**Addendum #2**  
**IFB07252019**  
**Room A257 Remodel**  
**McHenry County College**

**PHASE TWO DRAWING**

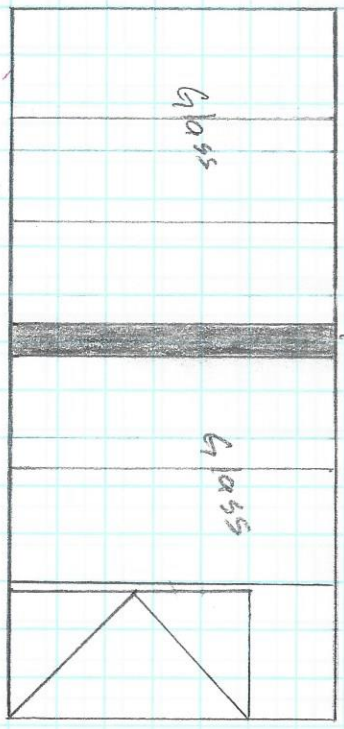
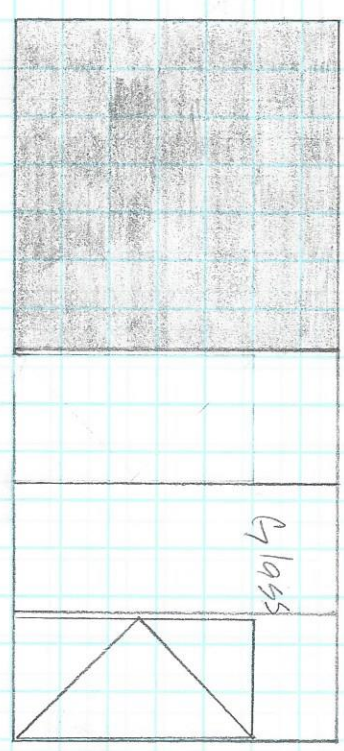
Existing Steel Support Column behind door in A257D

ADA Accessible doors  
 Heavy Glass Walls  
 Dropping Above  
 VLT on Concrete below Glass
